Evaluation Kit for RA4C1 Microcontroller Group
EK-RA4C1 v1
Errata

Renesas RA Family
RA4 Series

EK-RA4C1 v1 Errata

Figure 1. MCU Port Pin P600

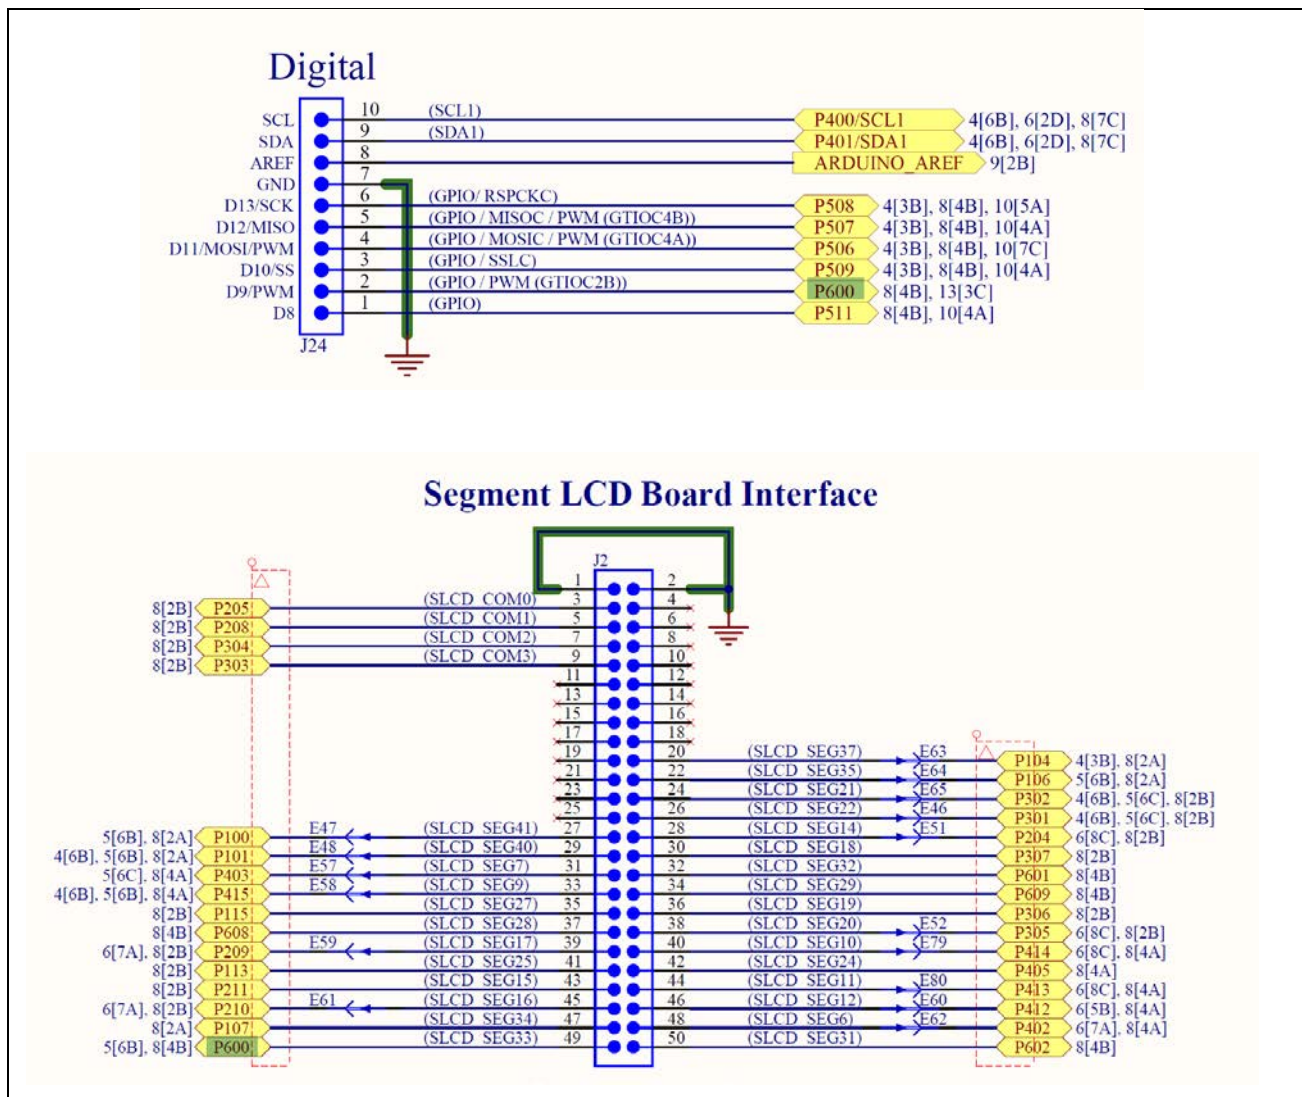
The RA4C1 MCU port pin P600 is used for both the Arduino and Segment LCD interfaces but there is no provision to isolate these connections. There may be contention if both interfaces are used simultaneously.

None.

Figure 2. Crystal Oscillator with incorrect load capacitance

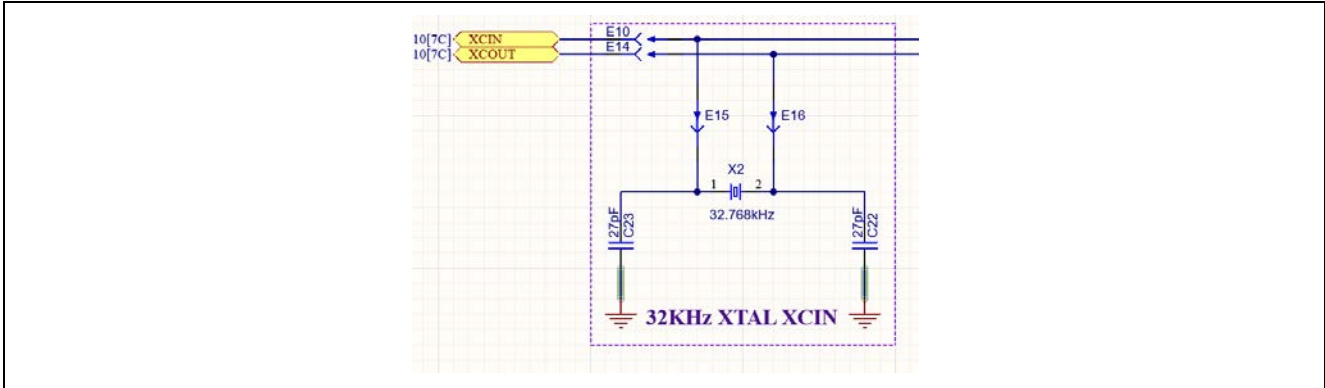
Due to incorrectly specified crystal load capacitance and capacitors C22 and C23, the RTC can be inaccurate in the order of 10 seconds every 24 hours. This is because the fitted crystal ABS07-32.768KHZ-9-T requires a 9pF load capacitance C_L , given by the formula $C22 = C23 = 2 \times (C_L - C_{stray})$, and so the load capacitors C22 and C23 should be significantly lower than the fitted 27pF capacitors.

To address this the user can replace the load capacitors, C22/C23, with 10pF parts, for example GRT1555C2A100JA02D. This value has been tested and found to be appropriate for the device and board configuration.

This issue will be corrected in later versions of the kit.
